PRODUCT CHANGE NOTIFICATION

#PCN-DC-EDYZ-12

Business Unit	Product Line Code	Type of Change	Action	Date of issue
DC	AAA	Aesthetic	Notify Distributors and Field	11/19/2012

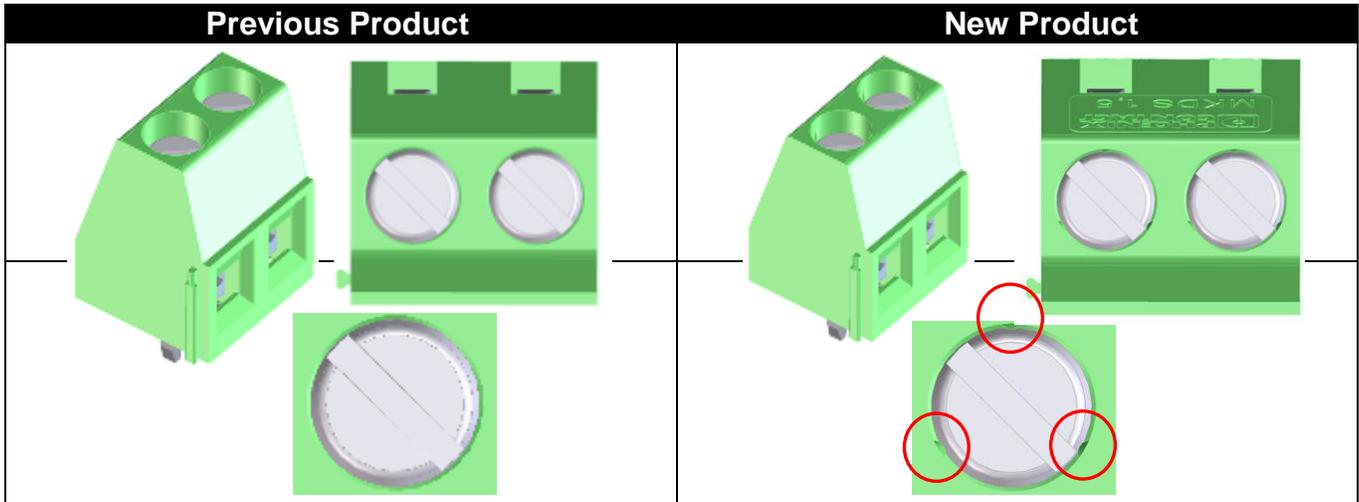
Due to our continuous improvement process the above mentioned articles will be delivered with an additional screw brake. Three plastic fins will be inserted in the screw shaft to prevent the closing of the clamping space during transportation. Dimensions and technical data remain the same. During the conversion period both versions will be delivered depending on the inventory.
